Re: Minor Project Refinement No. 10 for the TL 6975 San Marcos to Escondido Project

TL6975 San Marcos to Escondido 69 kV Project CPUC Minor Project Refinement Form

ATTACHMENT B
MPR-10 Figure

**TL6975 SAN MARCOS
to ESCONDIDO PROJECT**
MPR-10 Figure 1
Structure Location 54
San Diego County, CA

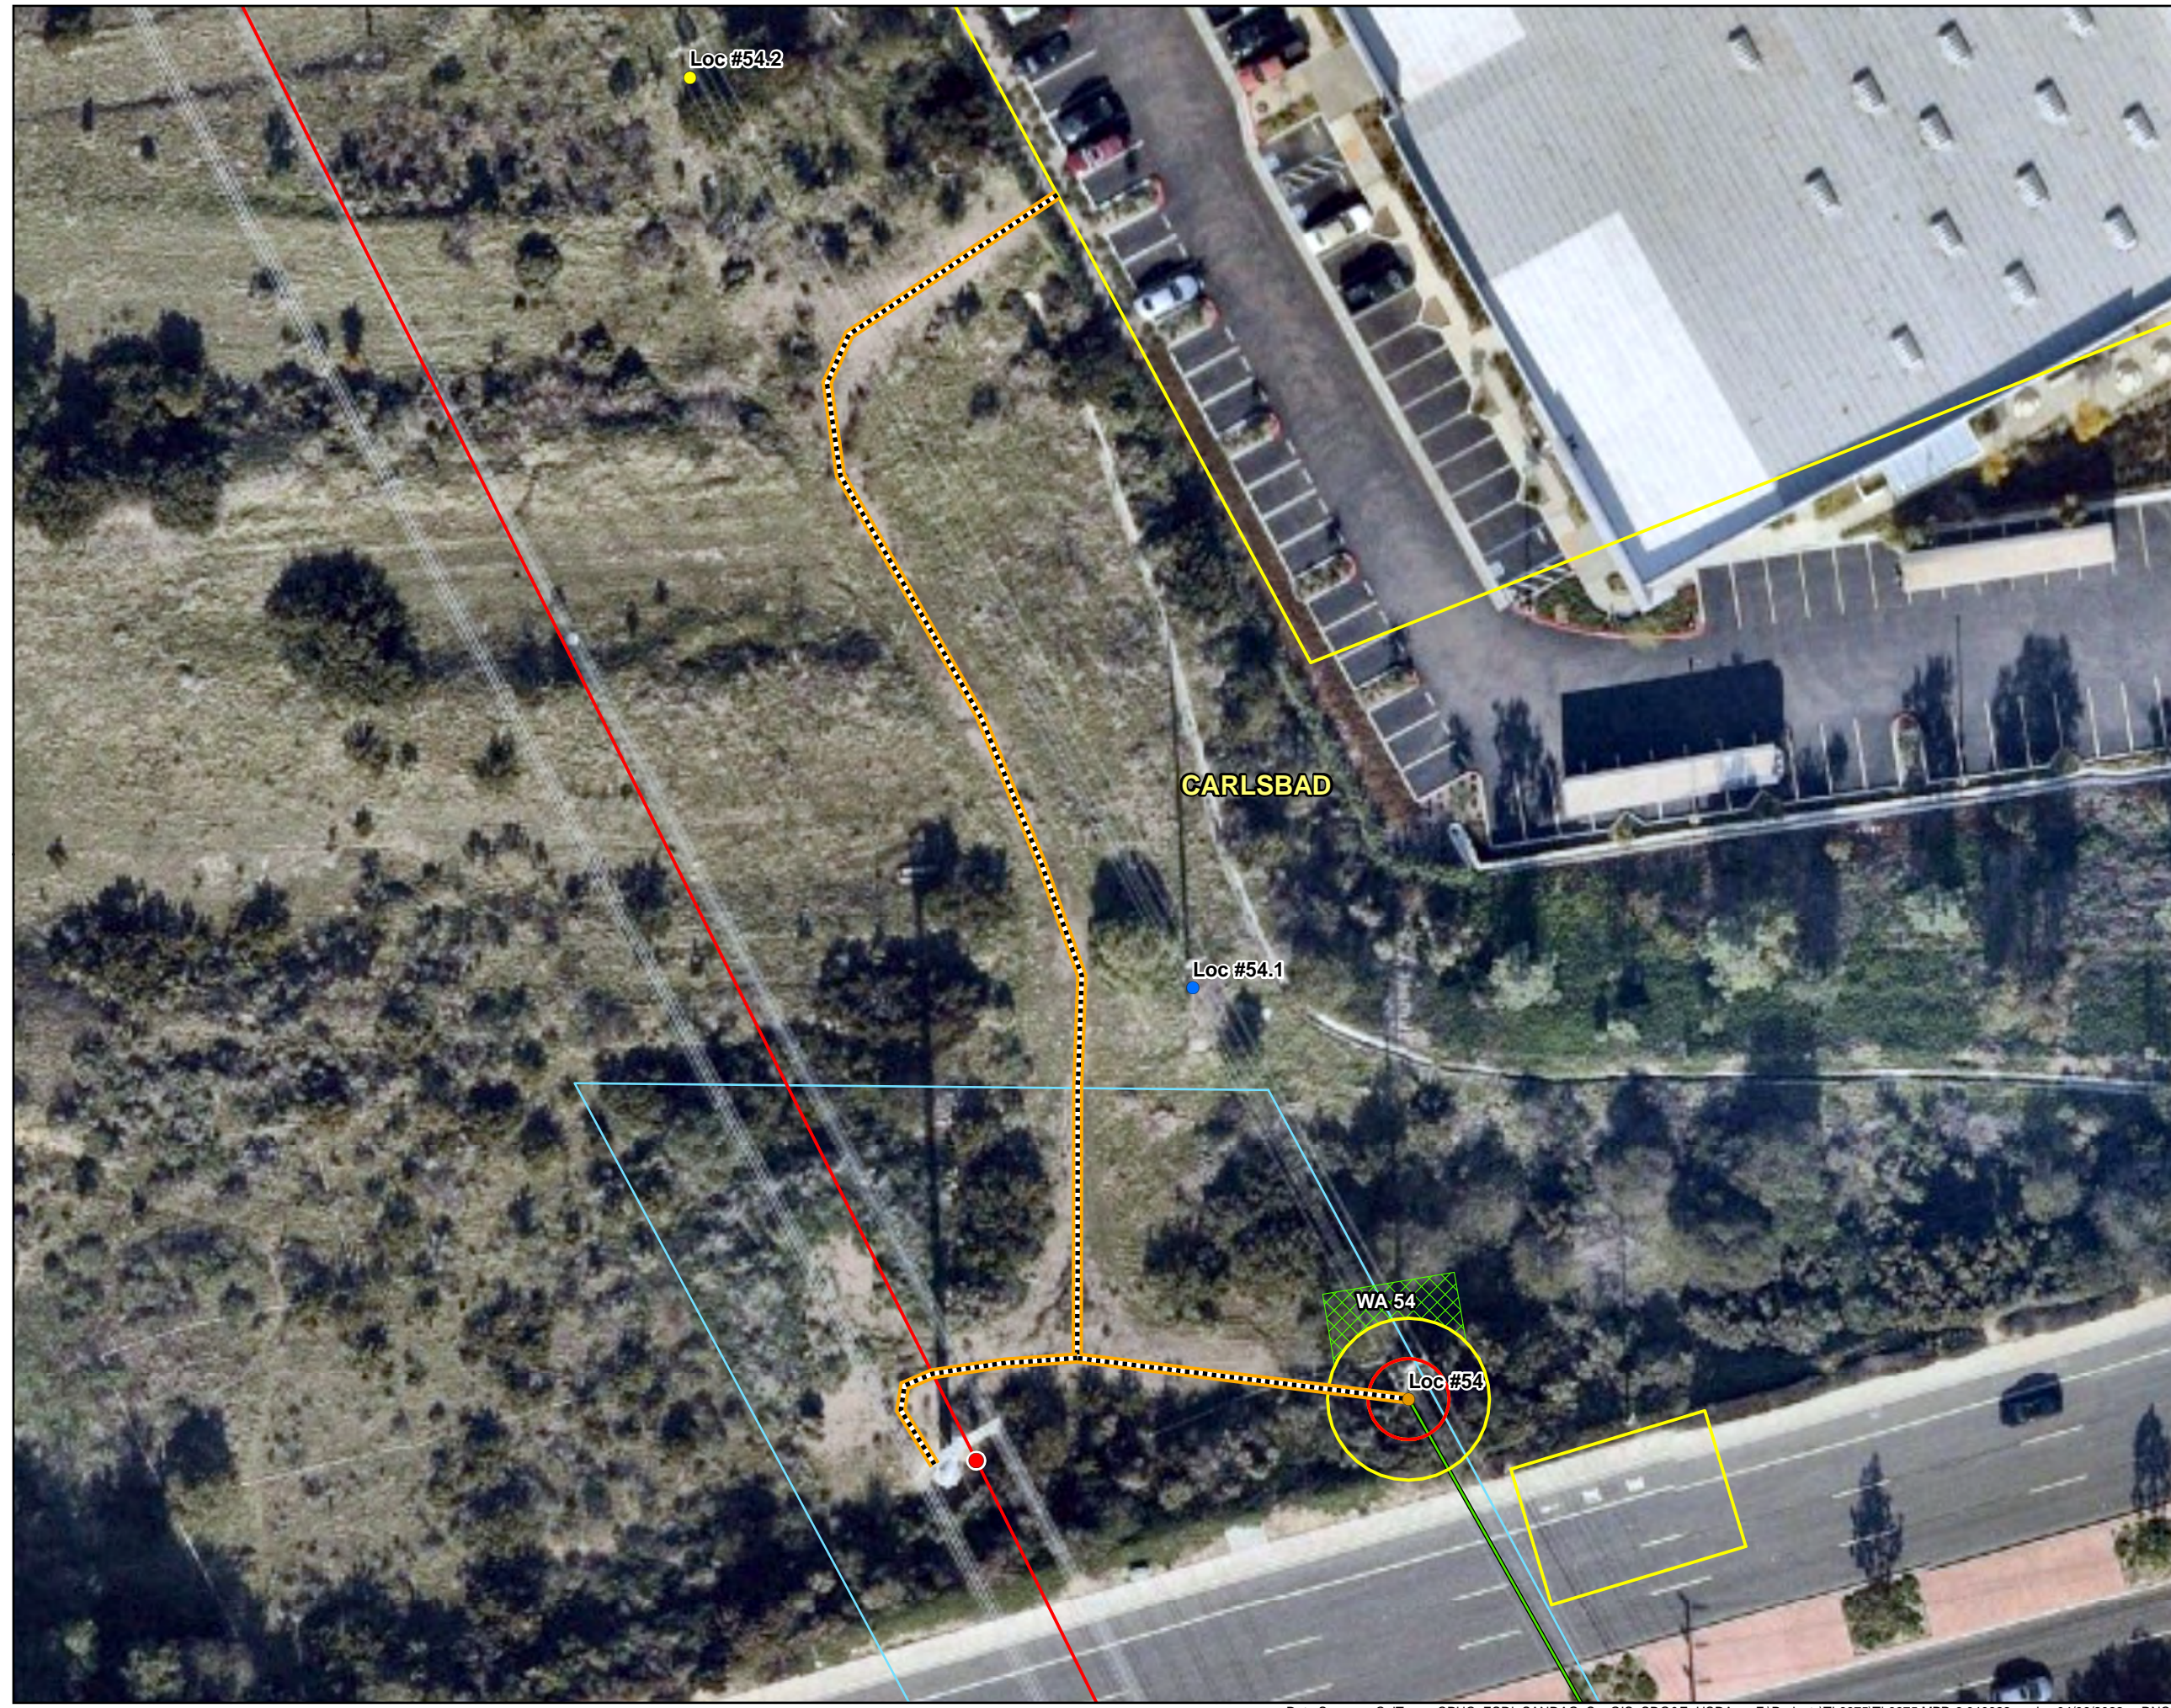
- **Location 54 Additional Work Area (WA 54):** WA 54 is located north of Location 54. The additional work area will be used for staging of equipment during foundation and pole installation activities, as well as the installation of conductor. The existing access road to WA 54 was not included in the Initial Study/Mitigated Negative Declaration (IS/MND) or NTP-1 Mapbooks and is therefore proposed for use herein as shown in **Attachment B, MPR-10 Figure**. A wood ramp will be positioned over the curb at the access road entrance in the business park to facilitate access for equipment and vehicles.

The existing pad and access road for the non-Project related existing pole west of Location 54 will be used for additional Project vehicle parking and temporary staging during construction activities at Location 54. Vegetation trimming will be required within WA 54. In addition, Location 54.1 has been changed from No Work/Information Only (as shown in the NTP-1 Mapbook) to Pole Top Work Only in **Attachment B**, as overhead work will be required at that location during wire installation activities. The overhead work required at 54.1 can be performed from the existing access road using a bucket truck, therefore an additional work area at this location is not being proposed. No work is proposed at Location 54.2.

- **Location 54 Additional Work Area (WA 54):** WA 54 is located north of Location 54. The additional work area will be used for staging of equipment during foundation and pole installation activities, as well as the installation of conductor. The existing access road to WA 54 was not included in the Initial Study/Mitigated Negative Declaration (IS/MND) or NTP-1 Mapbooks and is therefore proposed for use herein as shown in **Attachment B, MPR-10 Figure**. A wood ramp will be positioned over the curb at the access road entrance in the business park to facilitate access for equipment and vehicles.

The existing pad and access road for the non-Project related existing pole west of Location 54 will be used for additional Project vehicle parking and temporary staging during construction activities at Location 54. Vegetation trimming will be required within WA 54. In addition, Location 54.1 has been changed from No Work/Information Only (as shown in the NTP-1 Mapbook) to Pole Top Work Only in **Attachment B**, as overhead work will be required at that location during wire installation activities. The overhead work required at 54.1 can be performed from the existing access road using a bucket truck, therefore an additional work area at this location is not being proposed. No work is proposed at Location 54.2.

- **WA 54:** The existing work area at Location 54 does not allow for adequate space to perform construction activities at this location. The replacement direct-bury pole at Location 54 will be installed just north of the existing direct-bury pole in order to transfer the hardware and conductor from the existing pole to the replacement pole (See **Attachment C, MPR-10 Site Photographs**). Large equipment is not able to access the site from the south due to the steep slope, therefore WA 54 is needed to position equipment during pole and conductor installation activities. Since the new pole location cannot be accessed from Palomar Airport Road due to the steep slope and existing pole, the use of the existing access road to Location 54 is also critical to perform work at this location.

**TL6975 SAN MARCOS
to ESCONDIDO PROJECT**
MPR-10 Figure 2
Structure Location 51
San Diego County, CA

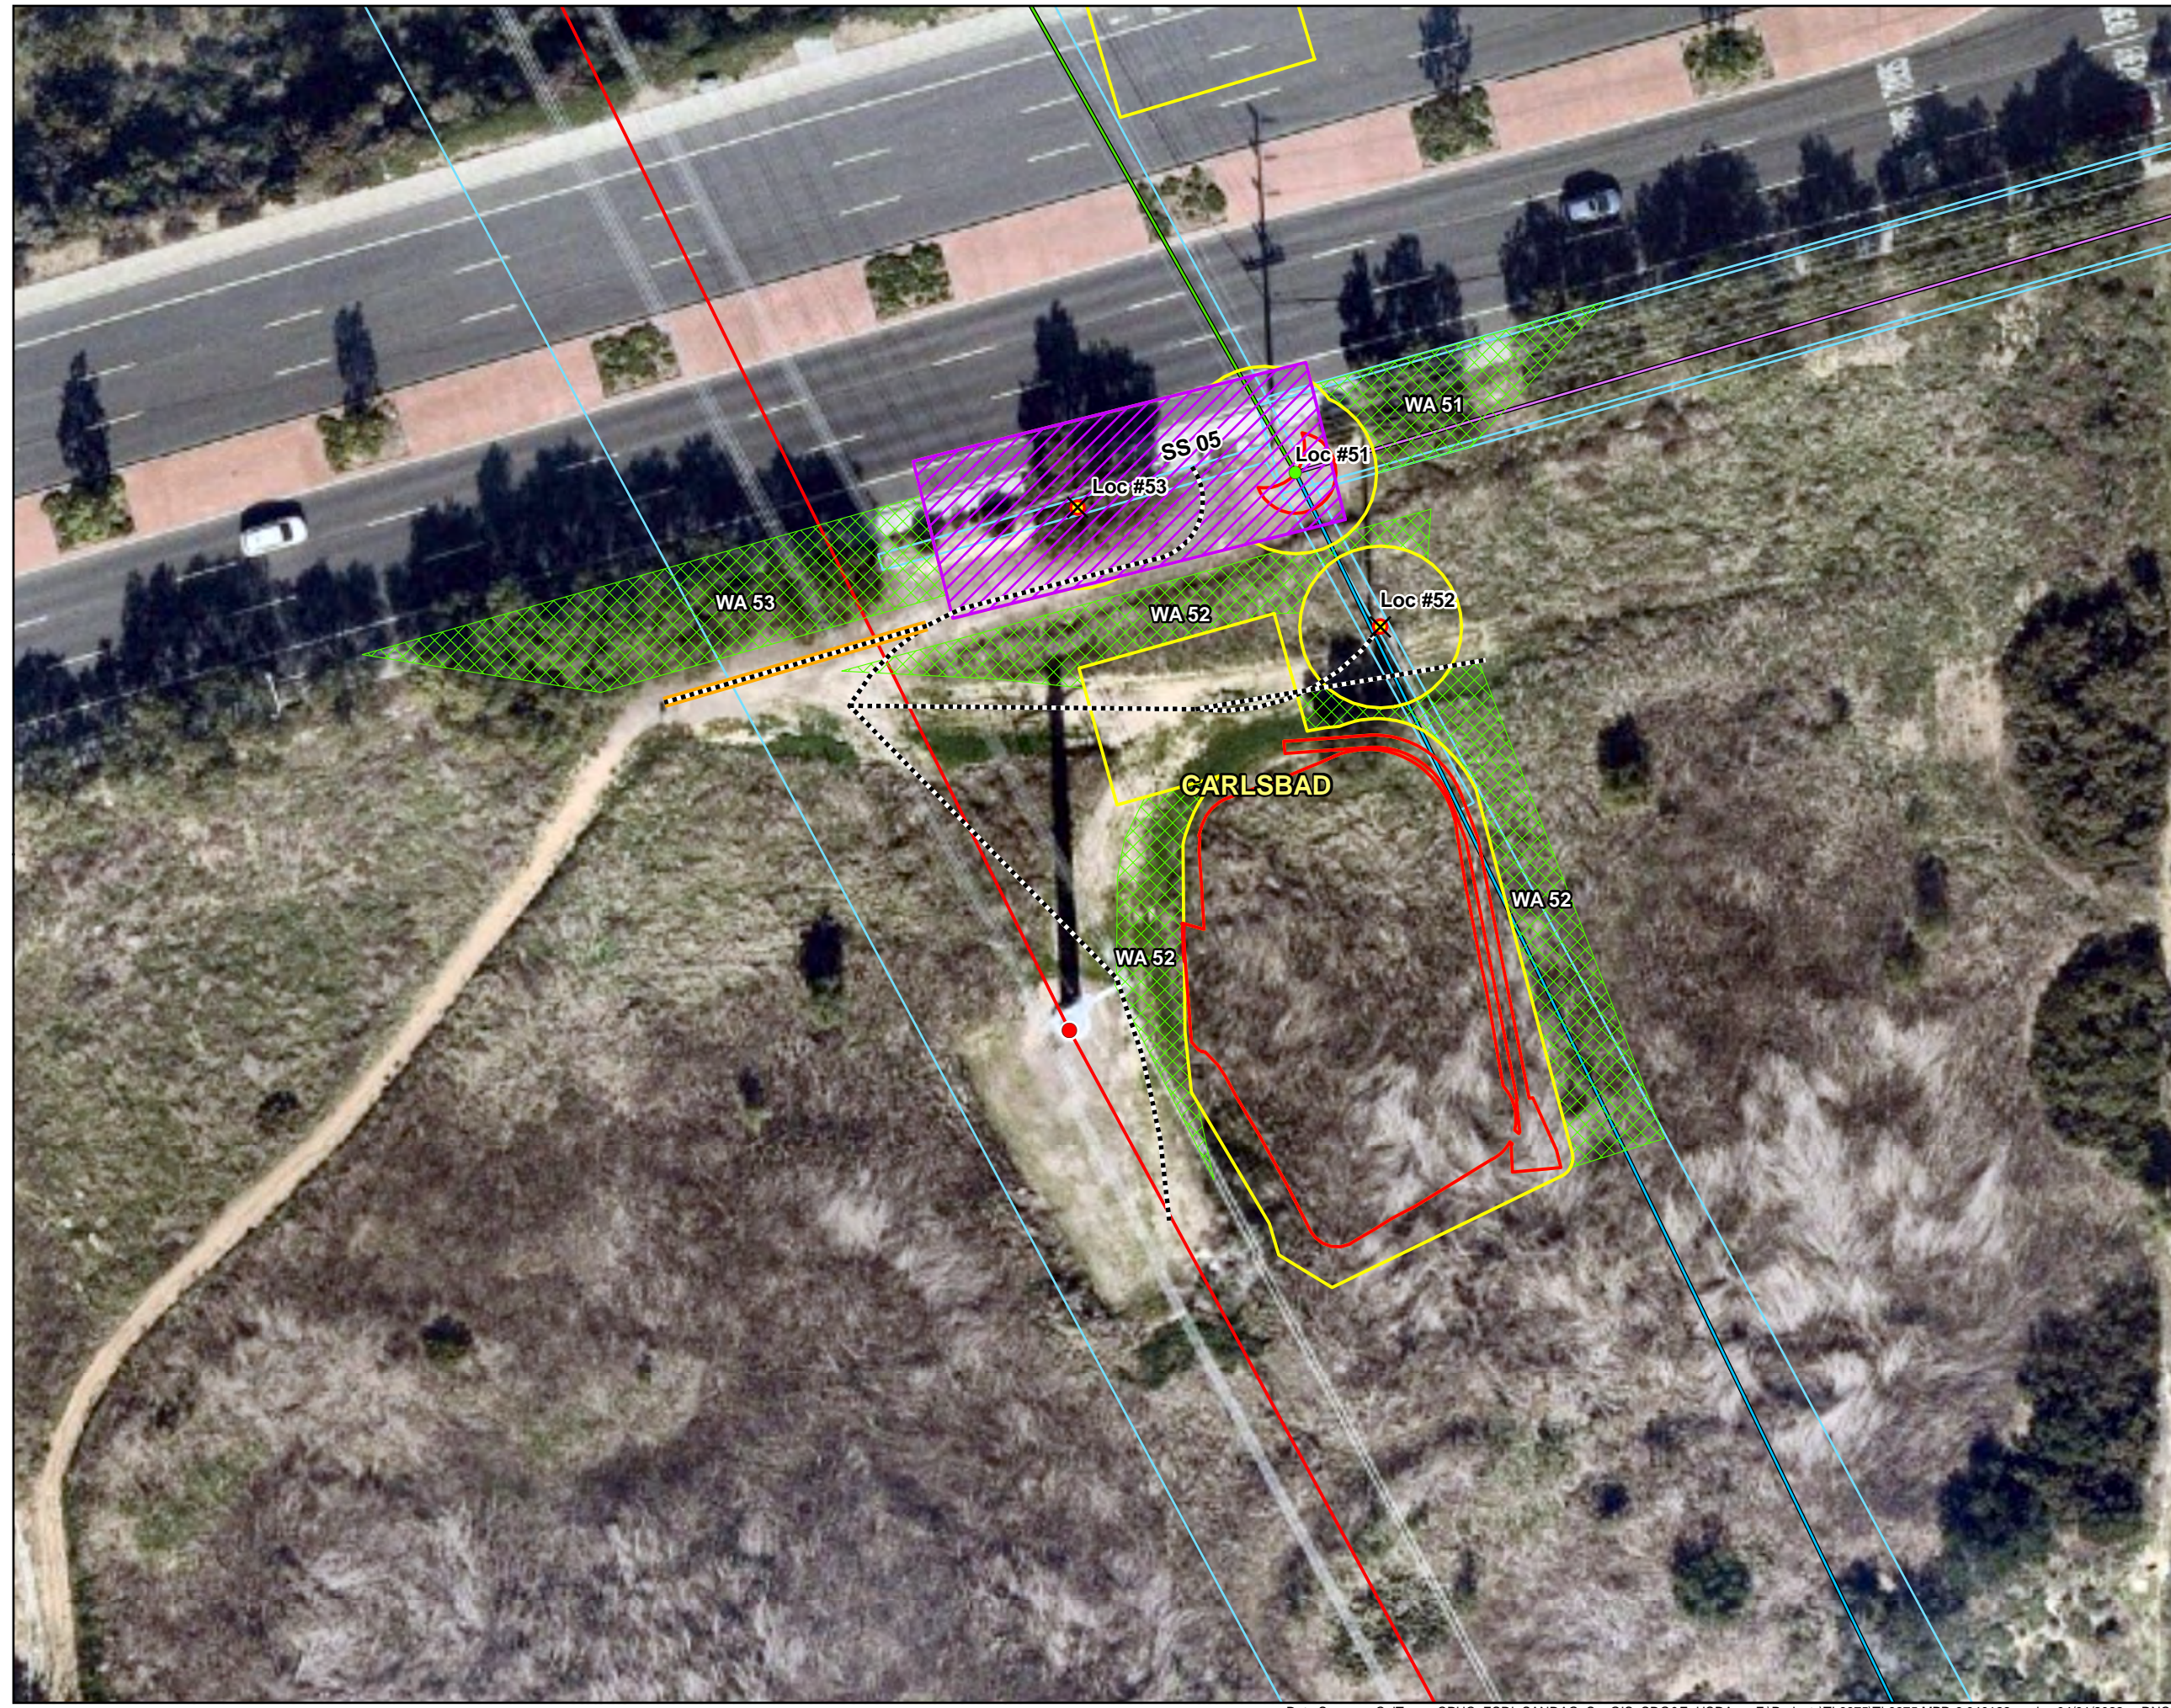
- **Location 51 Additional Work Area (WA 51):** WA 51 is located east of Location 51. WA 51 will be utilized for staging of materials and equipment during the installation of dead-ends on the pole at Location 51 and will allow for adequate space to set up a guard structure for wire installation over Palomar Airport Road. One Peruvian pepper tree is proposed for removal within WA 51. Tree removal will take place using a chainsaw and skid steer.

- **Location 52 Additional Work Area (WA 52):** There are three areas labeled WA 52 shown on **Attachment B, MPR-10 Figure** to facilitate the installation of the new pole and stringing of conductor at Location 51. One area is the slope between the two access road segments northwest of Location 52, which will allow for adequate space for one side of the 24-foot wide outriggers of the crane. The crane and the other side of the outriggers will be situated within the existing work area for Location 53 and stringing site 05. This area of WA 52 would also be utilized for temporary staging of materials during construction activities at Locations 51-53.

Another area of WA 52 is located south of the existing road west of Location 52. This area will allow construction equipment to access the existing work area labeled, “Permanent Work Area” from the existing access road during construction activities. The third area of WA 52 is located on the east side of the existing work area labeled, “Permanent Work Area.” This area would be used to position stringing equipment in line with Location 51 during the wire pull from Locations 51-58. Vegetation trimming will be required within WA 52 and the area labeled, “Permanent Work Area.”

- **Location 53 Additional Work Area (WA 53):** WA 53 is located west of Location 53 and stringing site 05. The additional work area will be utilized as an extension of stringing site 05 to accommodate the wire pulling equipment for the wire installation activities for Locations 25-51. Three ornamental Peruvian pepper trees are proposed for removal within WA 53, and one Peruvian pepper tree would be trimmed in order to make room for the wire pulling equipment and access to the site by the large equipment used to install the pole at Location 51.

- **Location 51 Additional Work Area (WA 51):** WA 51 is located east of Location 51. WA 51 will be utilized for staging of materials and equipment during the installation of dead-ends on the pole at Location 51 and will allow for adequate space to set up a guard structure for wire installation over Palomar Airport Road. One Peruvian pepper tree is proposed for removal within WA 51 (See **Attachment C, MPR-10 Site Photographs**). Tree removal will take place using a chainsaw and skid steer.

- **Location 52 Additional Work Area (WA 52):** There are three areas labeled WA 52 shown on **Attachment B, MPR-10 Figure** to facilitate the installation of the new pole and stringing of conductor at Location 51. One area is the slope between the two access road segments northwest of Location 52, which will allow for adequate space for one side of the 24-foot wide outriggers of the crane. The crane and the other side of the outriggers will be situated within the existing work area for Location 53 and stringing site 05. This area of WA 52 would also be utilized for temporary staging of materials during construction activities at Locations 51-53.

Another area of WA 52 is located south of the existing road west of Location 52. This area will allow construction equipment to access the existing work area labeled, "Permanent Work Area" from the existing access road during construction activities. The third area of WA 52 is located on the east side of the existing work area labeled, "Permanent Work Area." This area would be used to position stringing equipment in line with Location 51 during the wire pull from Locations 51-58. Vegetation trimming will be required within WA 52 and the area labeled, "Permanent Work Area."

- **Location 53 Additional Work Area (WA 53):** WA 53 is located west of Location 53 and stringing site 05. The additional work area will be utilized as an extension of stringing site 05 to accommodate the wire pulling equipment for the wire installation activities for Locations 25-51. Three ornamental Peruvian pepper trees are proposed for removal within WA 53, and one Peruvian pepper tree would be trimmed in order to make room for the wire pulling equipment and access to the site by the large equipment used to install the pole at Location 51.

- **WA 51:** The existing work area for Location 51 does not allow for enough space to perform construction activities on the east side of Location 51 due to the size of the pole and the equipment required to install the pole. WA 51 will be required for situating vehicles and equipment on the east side of the pole during the installation of dead-ends (located on the east side of the pole). The work area will also allow for adequate space to set up a guard structure for wire installation over Palomar Airport Road.

- **WA 52:** There are three areas labeled WA 52 to facilitate the installation of the corner pole and stringing of conductor at Location 51. One area is the slope between the two access road segments northwest of Location 52. It will be required to allow adequate space for one side of the 24-foot wide outriggers of the crane, which will be situated within SS 05 during the installation of the pole at Location 51. The crane does not have enough space within the access road to extend the outriggers without utilizing WA 52.

The portion of WA 52 on the west side of the area labeled, "Permanent Work Area" and south of Location 52 will connect the existing access road to a work area during the stringing of conductor. The portion of WA 52 on the east side of the area labeled, "Permanent Work Area" will be required to position stringing equipment in line with Location 51 during the wire pull from Locations 51-58.

- **WA 53:** During field review it was determined stringing site 05 needed to extend further east to create the angle required for adequate tension for the wire pull from Locations 25-51. Inadequate tension could cause strain on the arms of the new pole and new conductor and create safety concerns. The wire pulling rig would not be able to make the right turn into the work area from the access road entrance, therefore it will access WA 53 from the road using traffic control.
